ENVIRONMENTAL REVIEW TEAM REPORT

**HVASS PROPERTY
KENT, CONNECTICUT
KING'S MARK
RESOURCE CONSERVATION & DEVELOPMENT AREA**

**HVASS PROPERTY
KENT, CONNECTICUT
MARCH 1984**

Figure 4 WATERSHED MAP

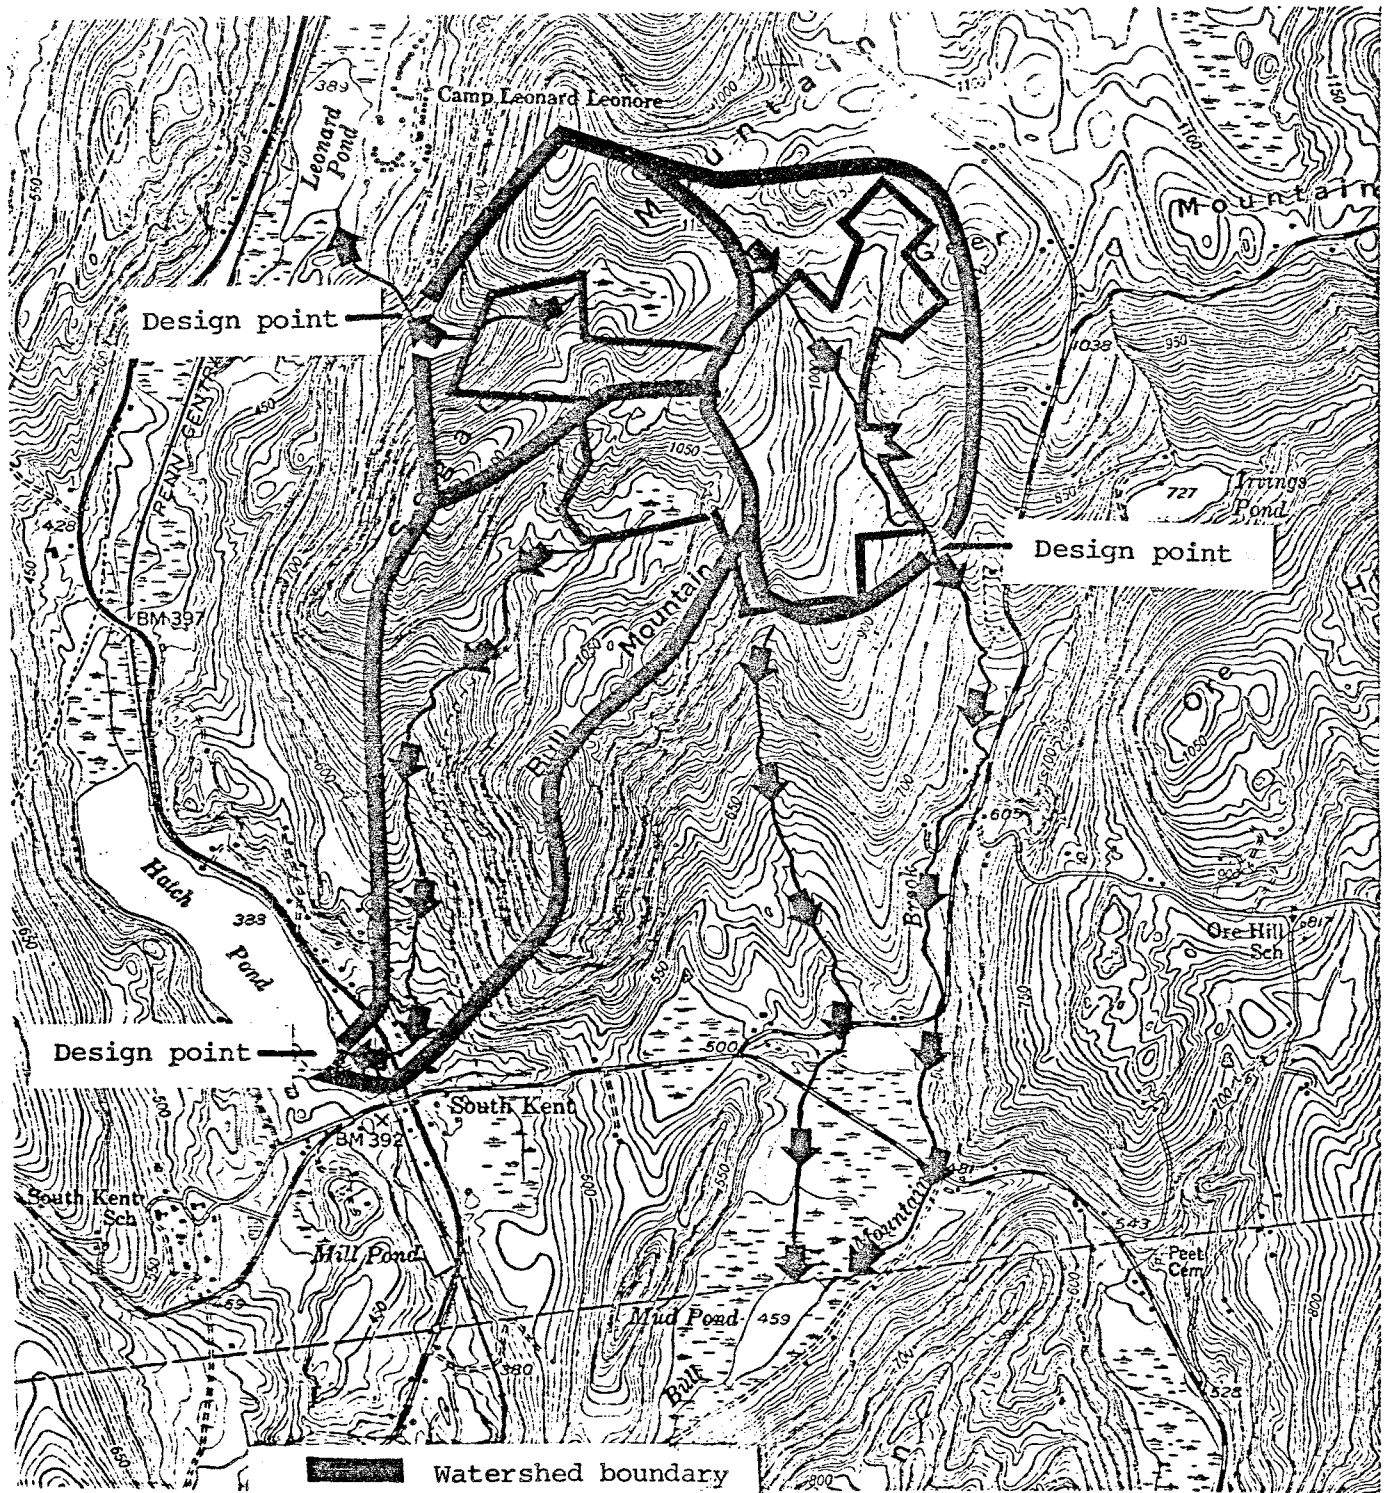
As shown in Figure 4, surface runoff from the eastern half of the site flows into Bull Mountain Brook via small intermittent streams and by sheet flow. Bull Mountain Brook traverses the eastern half of the site in a southeasterly direction enroute to Mud Pond. Drainage in the western half of the property is divided nearly in half. The northern portion of this area which include primarily lots 9 and 10, is drained by the only other perennial stream on the site. The stream flows generally in a westward direction from the site and ultimately discharges into Leonard Pond. The southern half of this area is drained by an unnamed stream whose headwaters originates in the low-lying swampy area on lots 7 and 8. This stream flows in a southwesterly course for about 2,500 feet then southerly for about 4,000 feet until it finally discharges into Hatch Pond. It should be pointed out that a small southwest portion of lot 4 is drained by an unnamed stream which ultimately empties into Mud Pond south of the property.

Estimate pre- and post peak flows in Bull Mountain Brook at the point shown in the watershed boundary map. These estimates are only for development in the eastern half of the site, which includes Lots 1-6 and 11-16. All peak flows given in units of cubic feet per second.

As shown by the accompanying table, peak flow increases at the design point on Bull Mountain Brook would increase about 12 percent for the smaller storms and 11 percent for the larger storms. Although these increases are not that high, the increases may cause some additional stream bank erosion. It is not expected, however, that the increases would create flooding problems downstream. Consideration should nevertheless be given to controlling the peak flow increases from the site since possible future developments within the drainage area for the brook could ultimately produce additional flooding. This runoff control could be accomplished by constructing a runoff detention basin on the site which could regulate flows to the brook.

Figure 7 DEVELOPMENT LIMITATION MAP

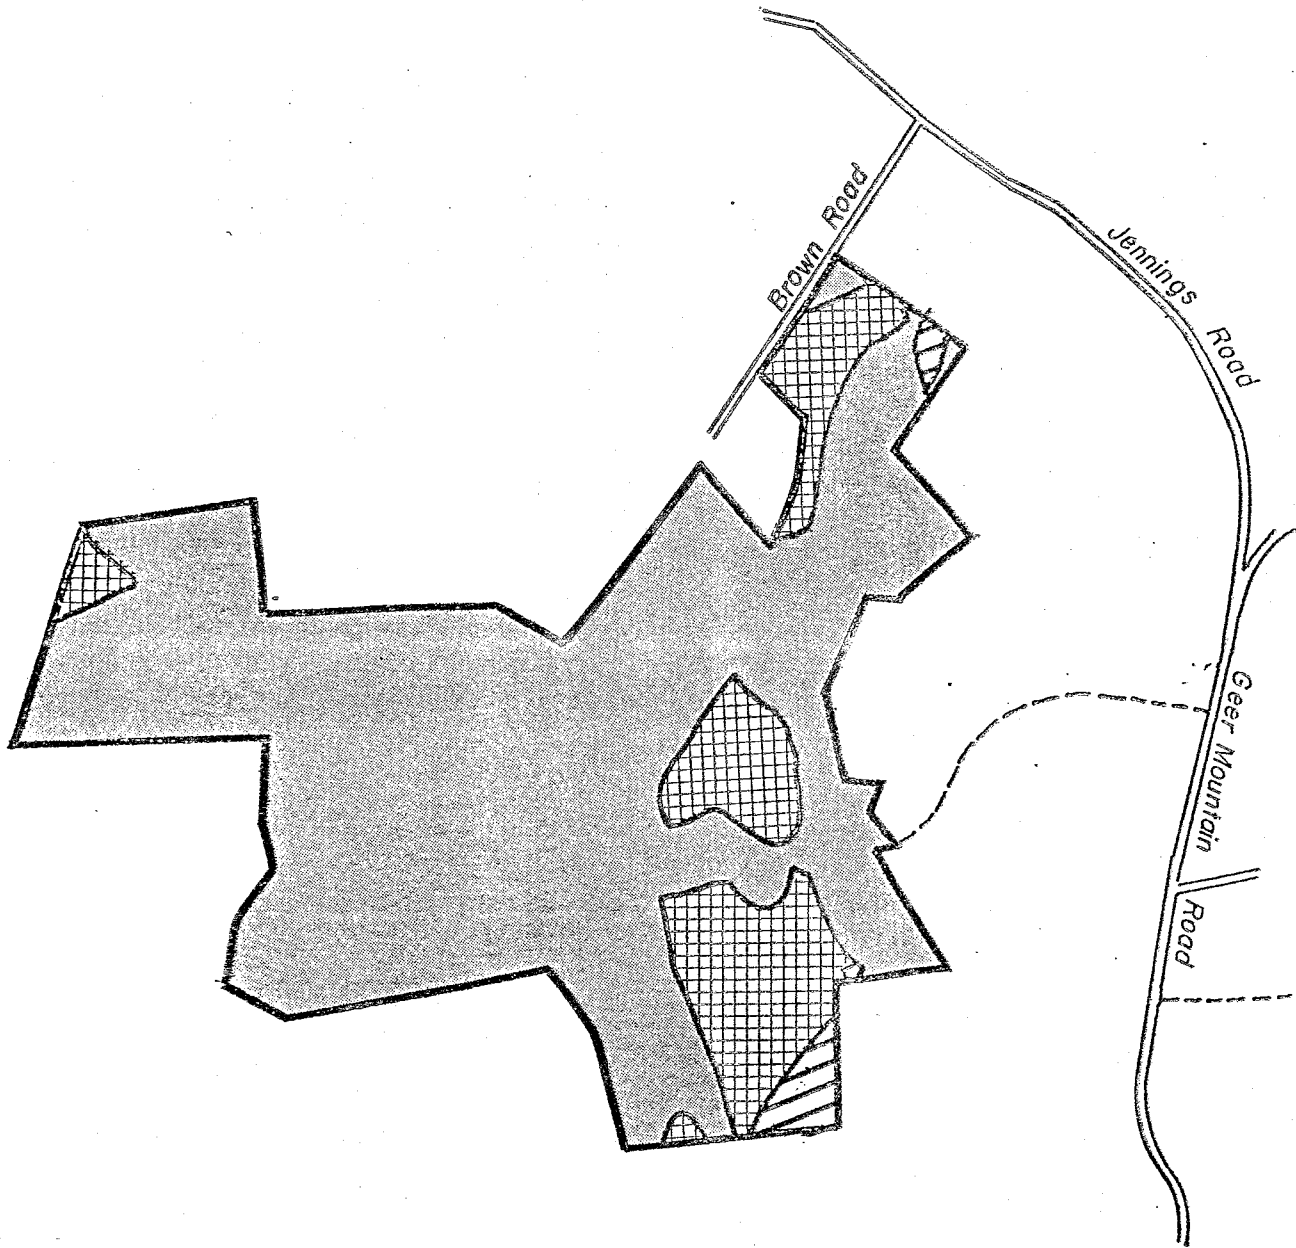
As shown in Figure 7, the soils on this site can be divided into three basic categories: 1) areas with severe development constraints, 2) areas with moderate to severe development constraints, and 3) areas with slight to moderate development constraints.

- . The proposed large lot subdivision as currently designed does not provide for any public open space areas.
- . The lots consume the entire property and render any future viable agricultural use of the site unlikely if not impossible.
- . Several lots, specifically lots 7, 14 and 15, appear to be questionable in terms of suitability for driveway construction and/or septic disposal systems.
- . The development, as currently proposed, will be visually intrusive from scenic Geer Mountain Road.
- . The proposed development does not call for any fire ponds, which are desirable if not necessary for fire safety.
- . The lots encompassing the farm fields are too large to easily mow, yet too small to feasibly plow or be agriculturally viable.

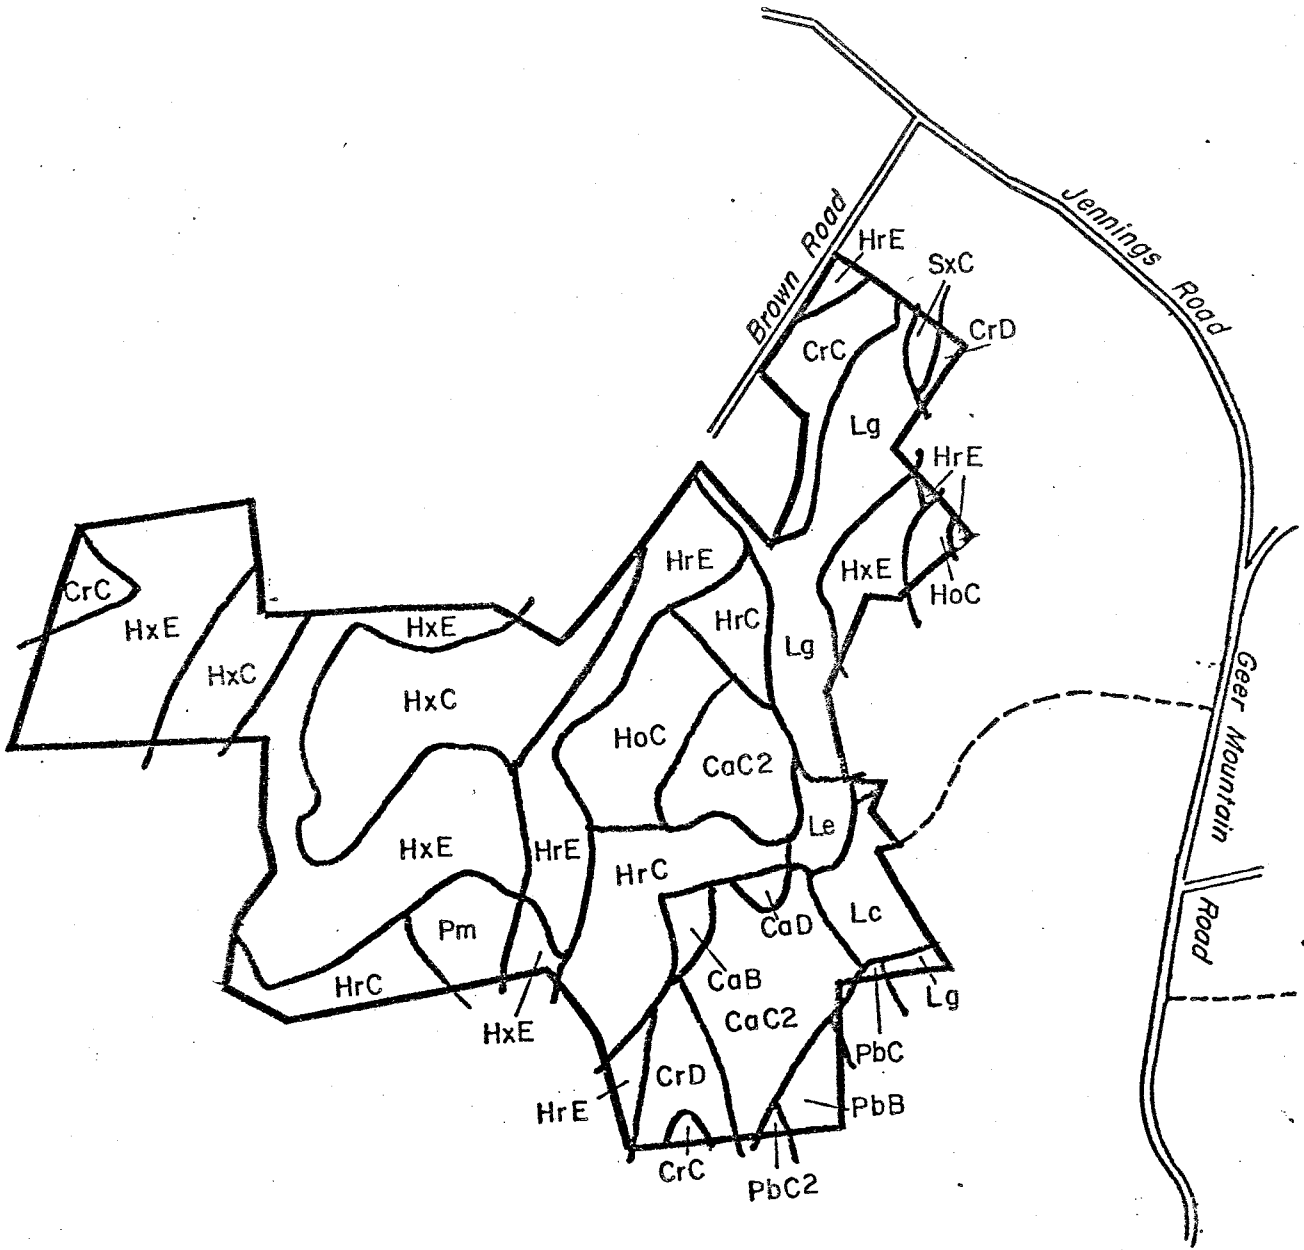
3. Consideration should be given to redrawing the property line between lots 3 and 4 to allow for protection of the agricultural field on lot 3 (see Figure 8).

4. The driveway access to lot 4 should be changed as shown in Figure 8 (i f f e a s i b l e) to reduce impact on the agricultural fields of lots 5 and 6.

5. Consideration should be given to constructing fire ponds on lots 7 and 14 in appropriate locations as shown on Figure 8 for fire safety.

7. A 10' pedestrian right-of-way should be granted to the Town of Kent (as shown on Figure 8) allowing public access into the rear of Emery Park.
